D2 Subway Urban Design Process & Focus Area Summary Report

March 2020

First Draft - 20% Submittal

Victory-Perot Focus Area Coordination

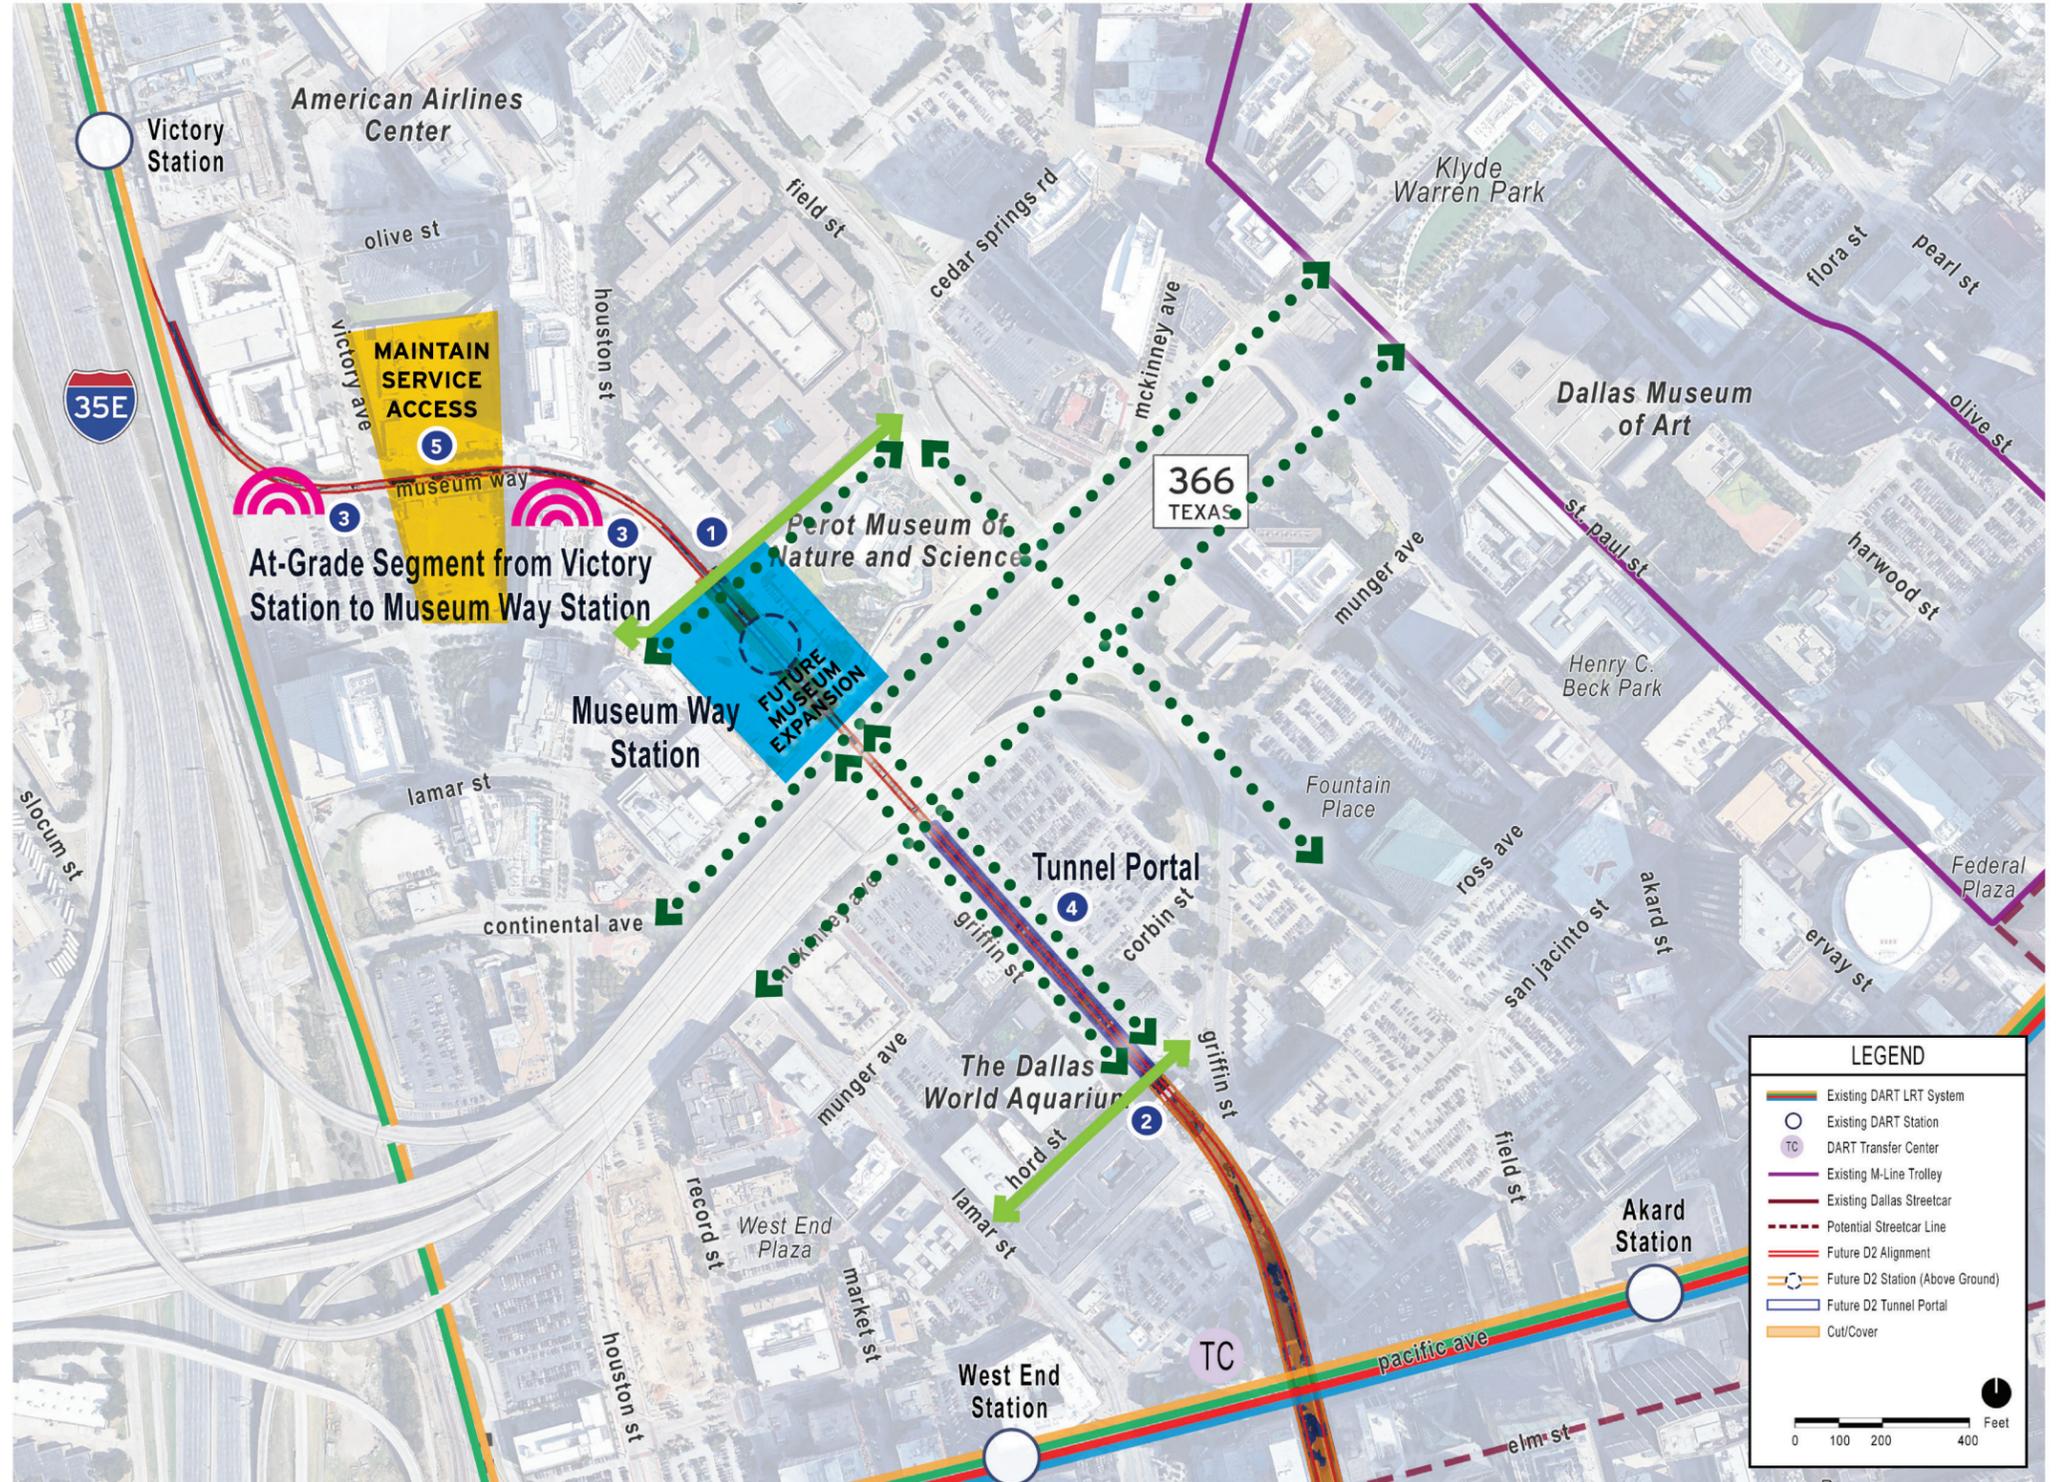
- 1 Stakeholders indicated potential redevelopment north of the Perot Museum with River Street being an important connector. Traffic signalization would be proposed at River Street and Field Street. It would be desirable for River Street to cross the tracks north of the DART Museum Way Station in this location.

- 3 Noise is a stakeholder concern where the train tracks curve near Victory Park residential buildings.
- 4 Based on the vision of the Dallas 360 Plan for this area, pedestrian connections along Broom Street and McKinney Avenue adjacent to Woodall Rodgers and along Field Street could see future improvements. Stakeholders propose additional pedestrian connections along either side of the tunnel portal and Museum Way Station in this area. *See Examples 1, 2 and 3 photos*

- 5 DART tracks will exist in the center of Museum Way within the 35 feet of DART owned ROW. DART will work with stakeholders on the cross section of the new Museum Way condition to include vehicular travel lane(s), a possible bike lane, on-street parking and a pedestrian zone. Stakeholder discussion included maintaining service and garage access points that exist mid-block along Museum Way. *See Existing Museum Way photo.*

River Street was identified by stakeholders as an important connection. For this reason an improved city street is shown. The Museum Way Station has been modified to shorten the platform length to an acceptable standard to allow a connection of River Street (by others) to the north of the station. South of the station, reconfiguration of Broom Street to provide a wider pedestrian edge to the Perot Museum and adjacent destinations is seen as a positive to all stakeholders. Depressing the tracks at the station may also allow for D2 to pass under Woodall Rodgers without any reconstruction of the on-ramp west of the Field Street intersection. This may also shorten the length of the tunnel portal in order to maintain Hord Street as a vehicular connection. Maintaining a strong pedestrian connection north and south connecting both sides of Woodall Rodgers is important.

DART is open to plans for future expansion of the museum over the station and future development and connections over the tunnel portal. The design (by others) would be subject to review and coordination with DART. DART recognizes the potential that future development has for unifying this area of downtown.

Museum Way Cross Sections

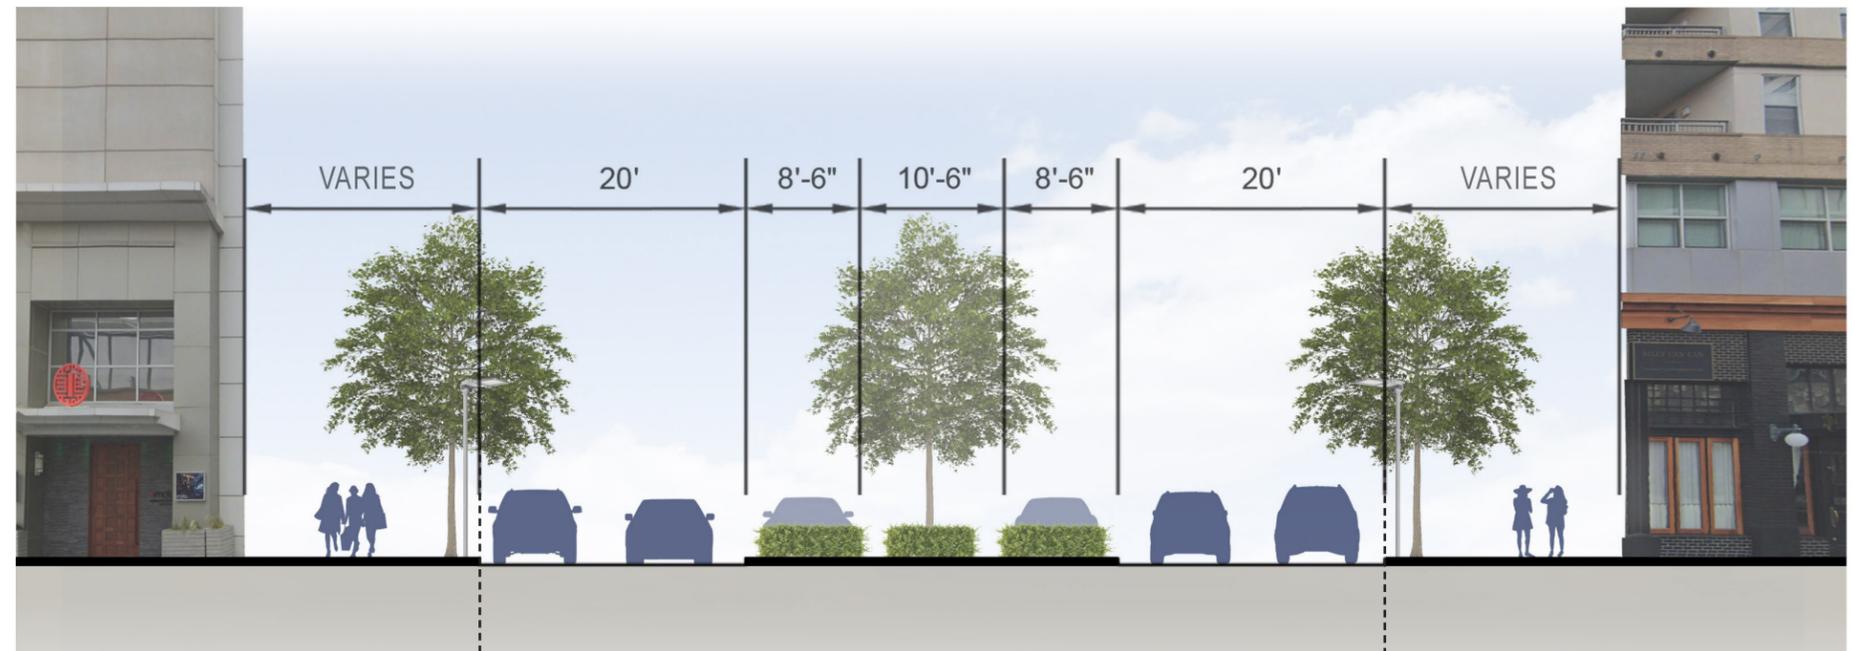
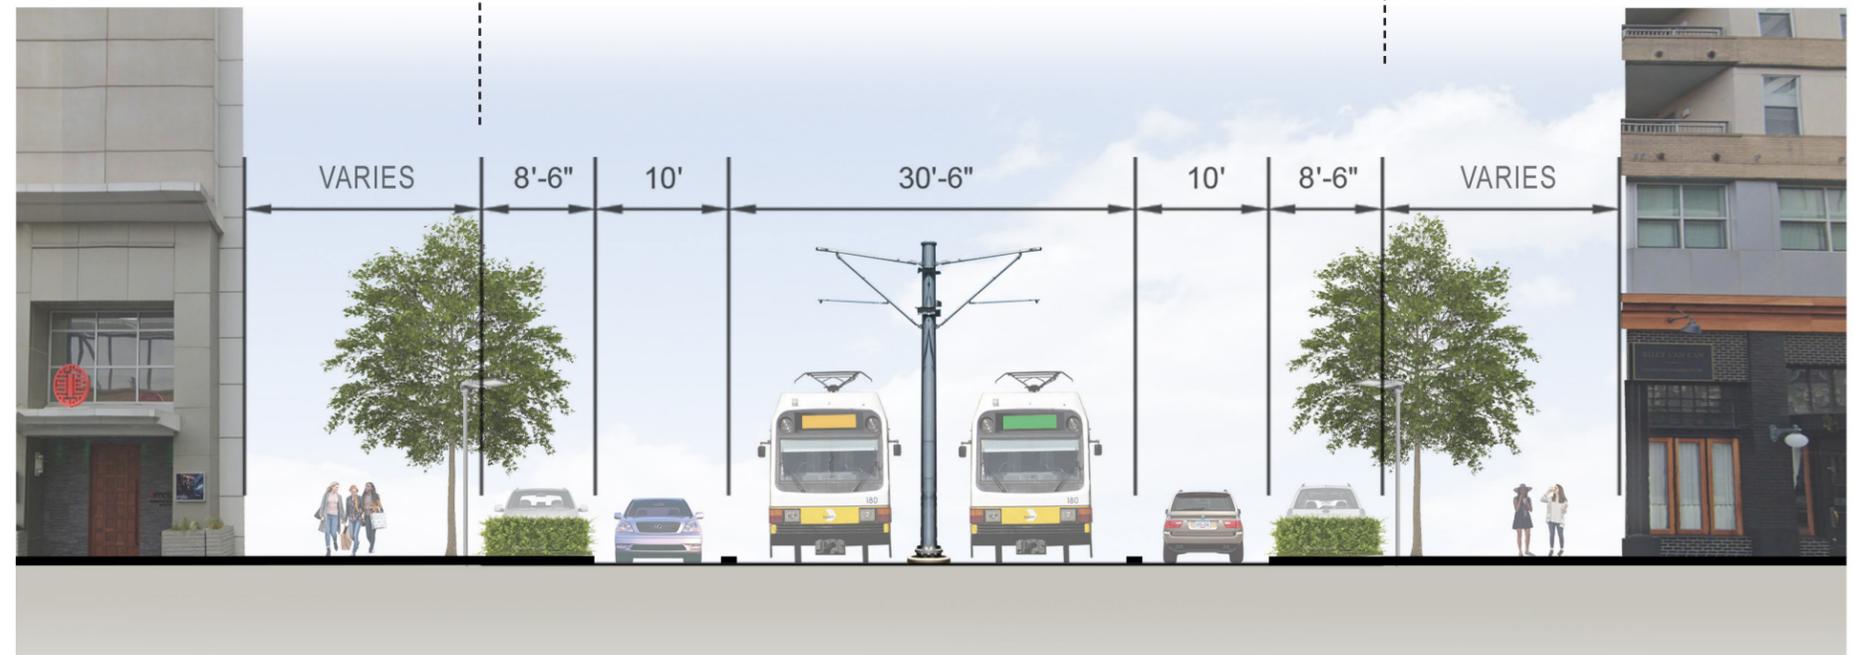
- Stakeholders asked about the proposed new cross section for Museum Way. DART currently owns a 35'-0" wide section centered in the Museum Way ROW. The D2 tracks will replace the current median and parking in this location. Stakeholders want to maintain mid-block access for parking garage entries. The cross section will need to be coordinated with the City - it could potentially be one lane of travel each direction either side of the new tracks with on street parking and bike lanes.

STAKEHOLDER COMMENTS (AUGUST 2018)

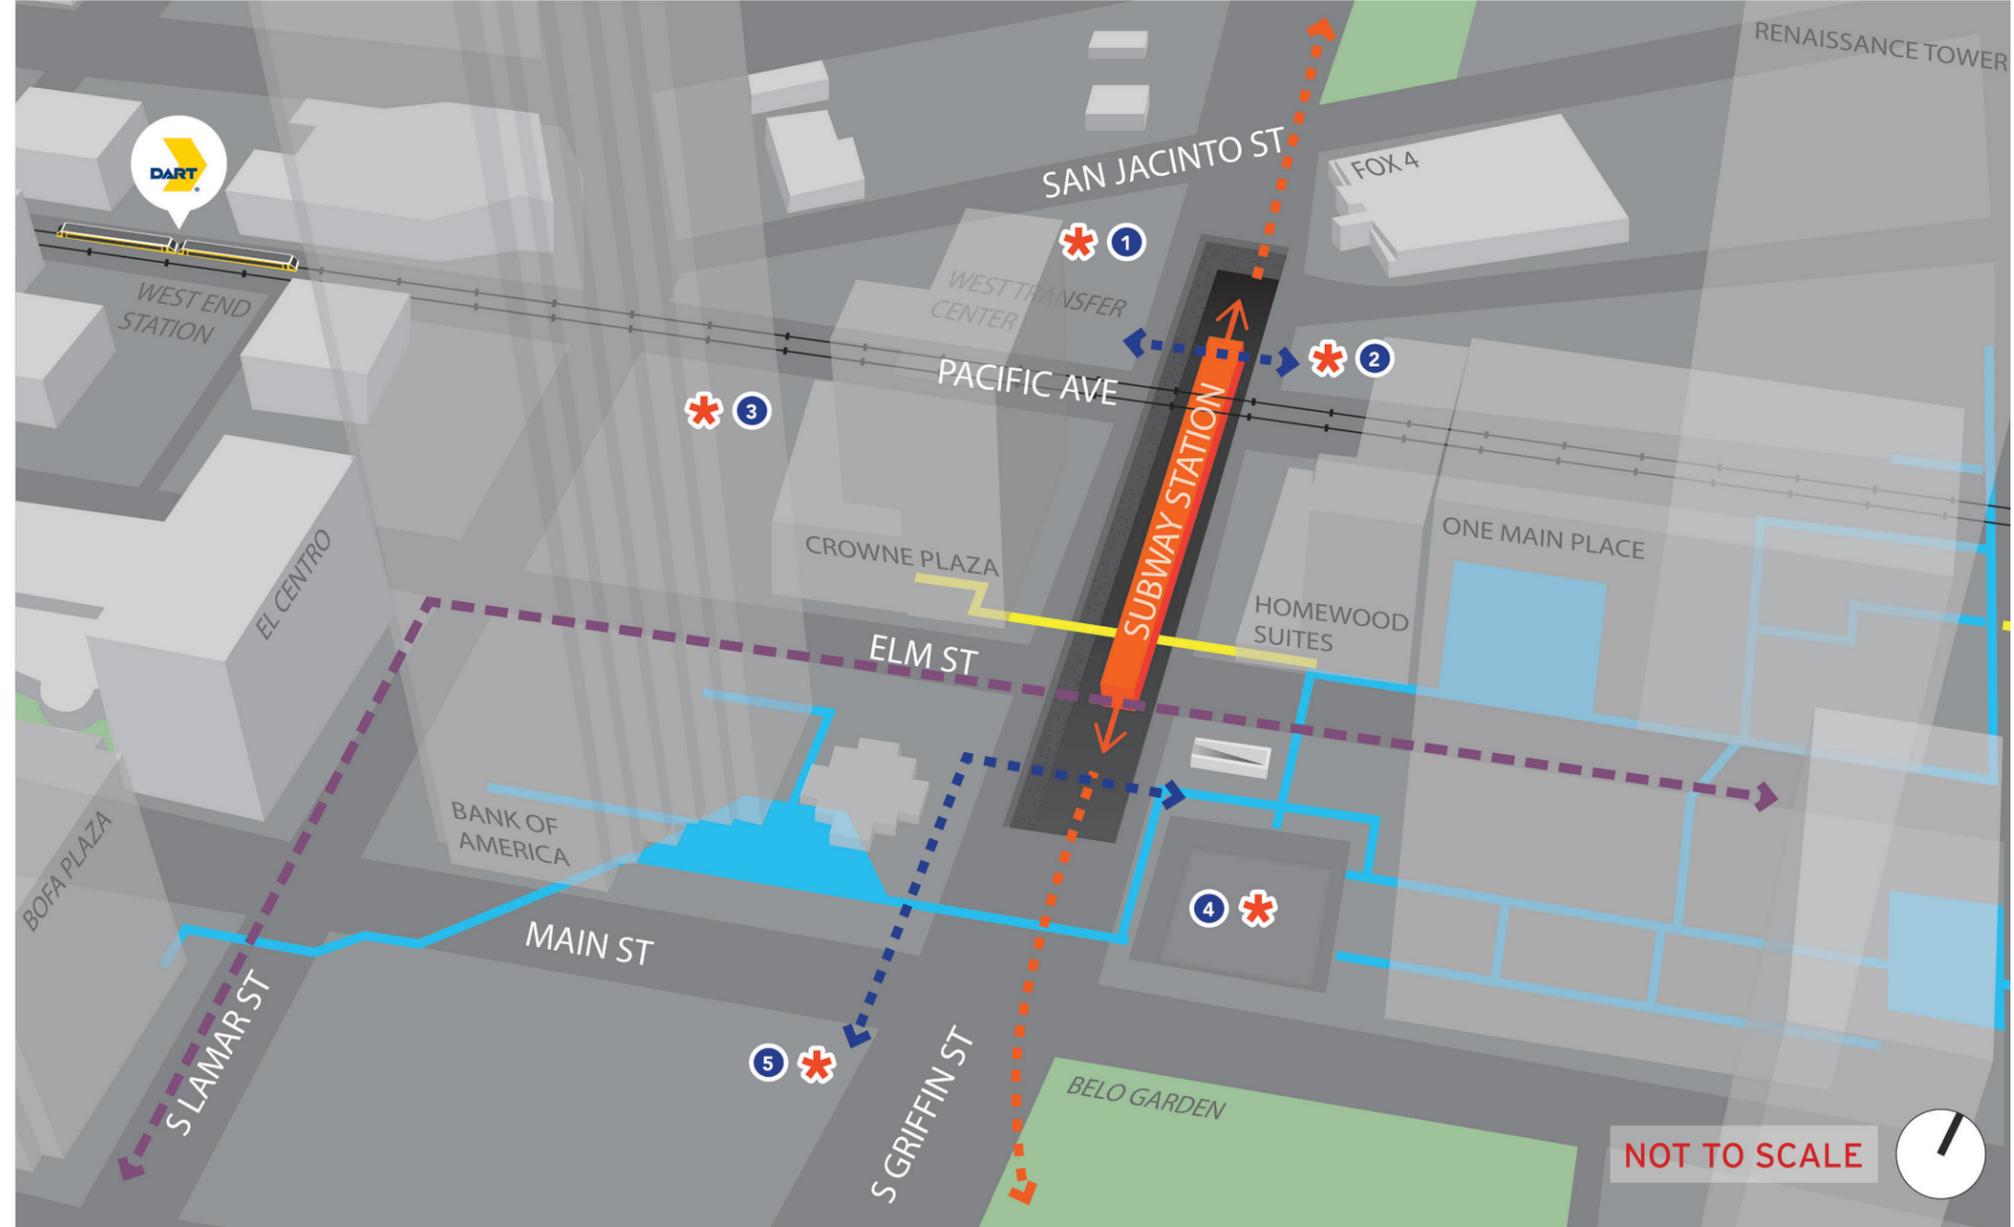
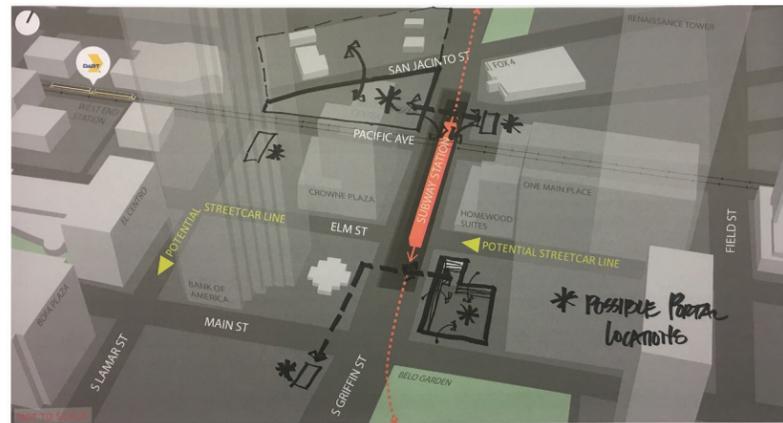
- 1 Stakeholders agreed on several potential sites either side of Griffin Street and at either end of the station, including a potential multi-story transit center that completely reimagines the space that currently serves as the West Transfer Center. Thinking big, stakeholders felt that the block north of the existing transfer center may be needed as part of this potential development plan. See Example 1 photo.

- 3 The DART owned Rosa Parks Plaza is also a potential space for a portal location. The portal would reach west and provide direct access to Lamar Street. Many stakeholders have indicated their desire to access the portals in urban plaza areas and near parks. See Example 3 photo.

- 4 Reimagining the sunken plaza directly west of the Westin Dallas Downtown Hotel is another potential site for a subway pedestrian portal. National precedents and projects around the world show the possibility this space has if redesigned to allow direct at grade pedestrian access on all three sides into the plaza. The design could be accomplished to keep the space vibrant and active, take full advantage of existing and future restaurant and retail services, connect where appropriate to the existing tunnel system in this location and provide direct subway portal access. See Example 1 photo.

Based on feedback received after the Focus Area meeting held August 23, 2018, a few pedestrian portal areas originally identified by stakeholders as opportunities have been ruled out for various reasons.

Through continued design development, it has become a challenge to locate pedestrian portals that provide direct access to the south end of the subway platform. Constraints including existing utilities and limited available public ROW make placing portals along Elm Street difficult. The Urban Design Plan will focus on the development of pedestrian portals at the WTC, Rosa Parks Plaza, the northwest corner of Lamar Street and Pacific Avenue and the northeast corner of Griffin Street and Pacific Avenue as potential locations based on stakeholder feedback.
